City of Beaufort

DESIGN REVIEW BOARD MEETING

**A. Coastal States Bank, PIN R120 004 000 0012 0000, 1203 Boundary Street.
Applicant: Dana McClure, Warner Summers Architecture (22-06 DRB.4)**

The applicant is proposing a new single-story bank approximately 2,800 SF with attached 2-lane drive-thru.

PREVIOUS SUBMISSION

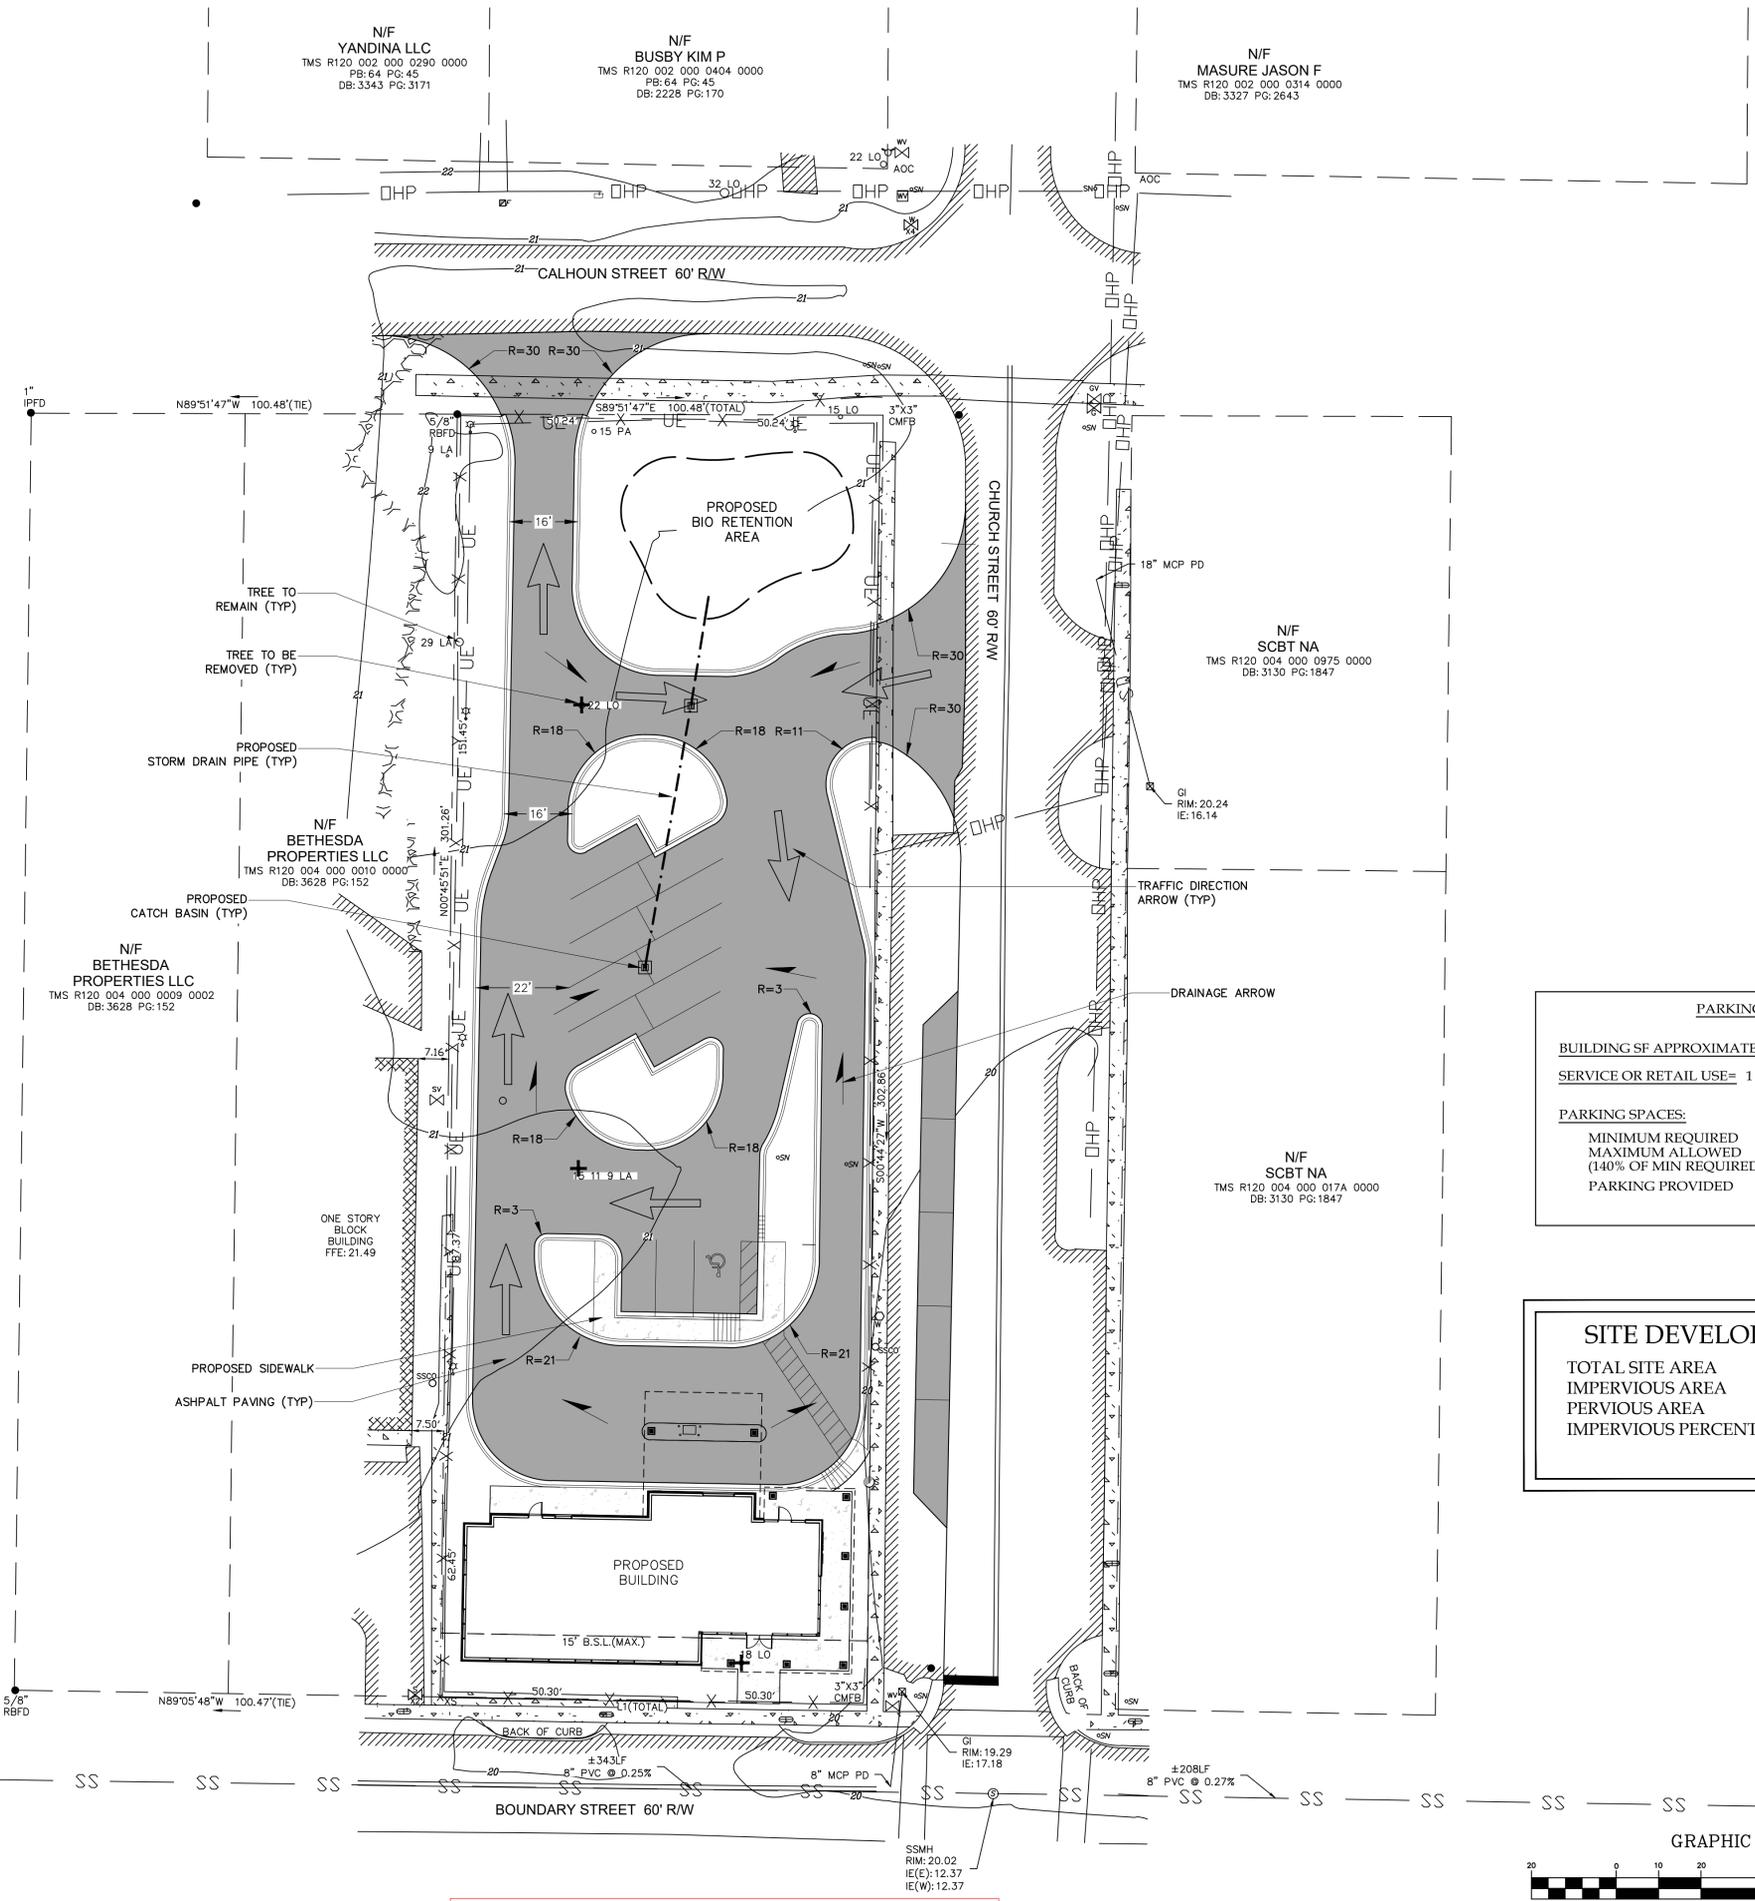
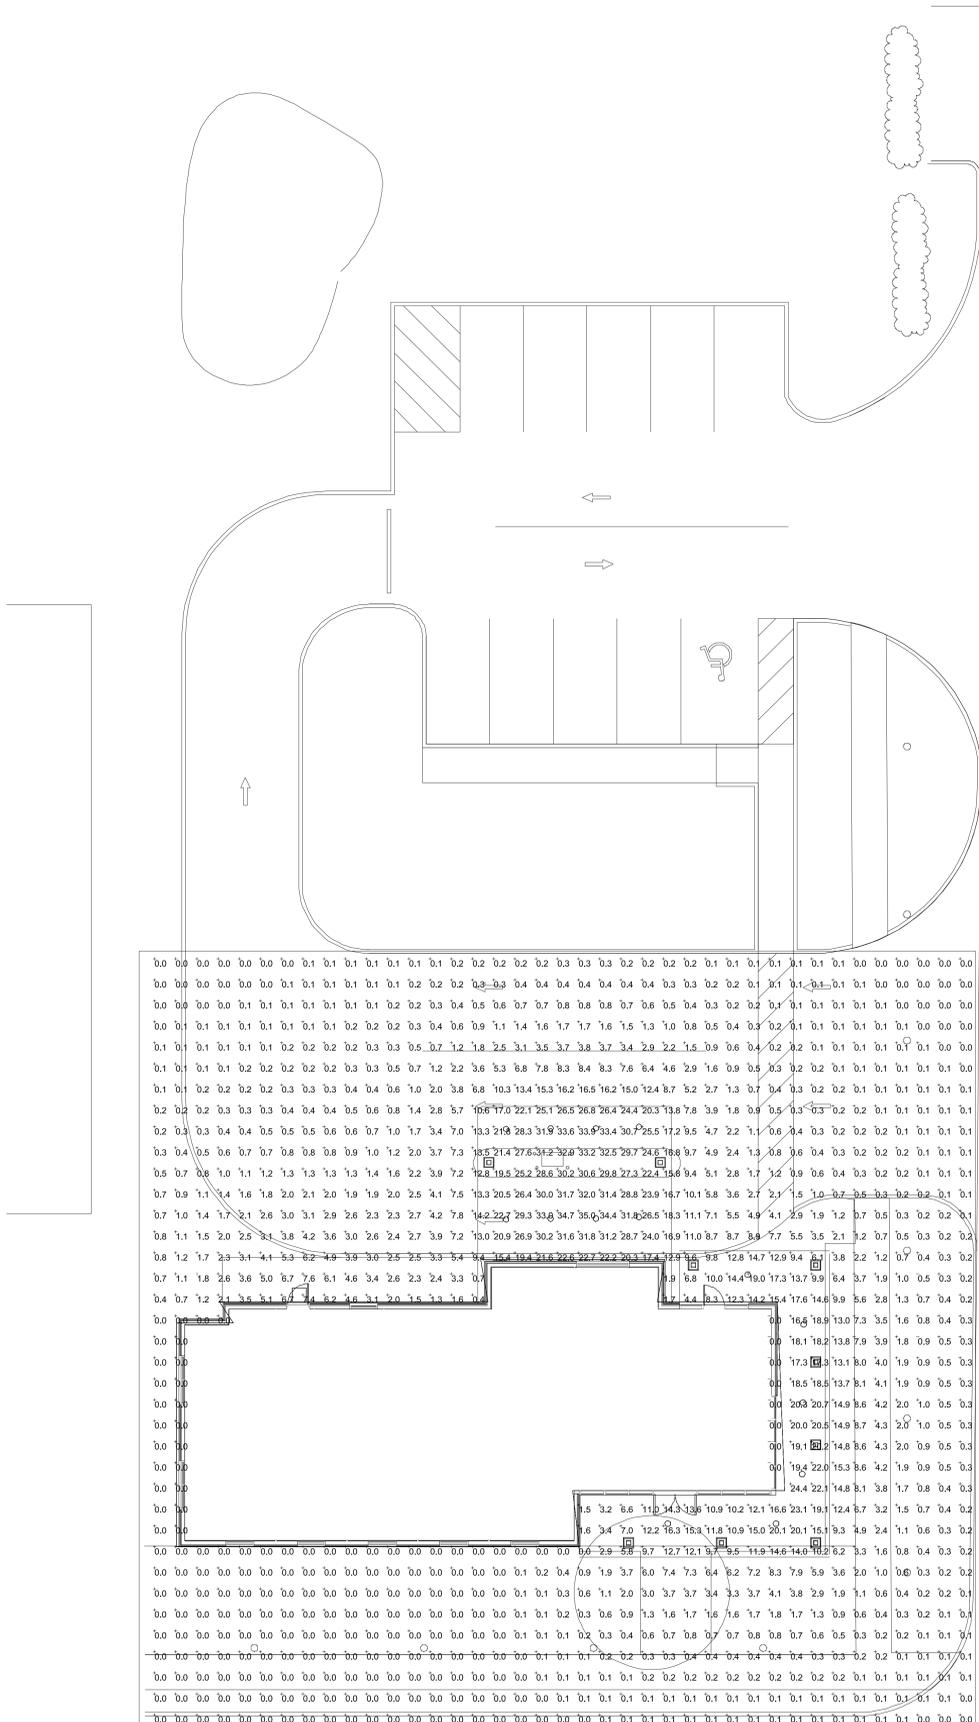
1. Applicant to recalculate the minimum and maximum parking requirements with the potential to use credits for on-street parking on the Church Street development.

2. Applicant to look into reducing the impervious surface of the parking and reducing the parking on-site in general to allow for a potential future development on the Calhoun Street and Church Street corner, as well as submitting a master plan showing this future development.

- i. The applicant has corrected the minimum (7) and maximum (10) parking requirements and is proposing 9 onsite parking spaces. The applicant is proposing 6 on-street parallel parking spaces in site plan option 1 and 9 on-street parallel parking spaces in site plan option 2.

- i. Site plan Option One now proposes impervious surface coverage of 47% and site plan Option Two now proposes impervious surface coverage of 49.8%. These proposed impervious surface coverages are less than previous proposed 66% coverage.
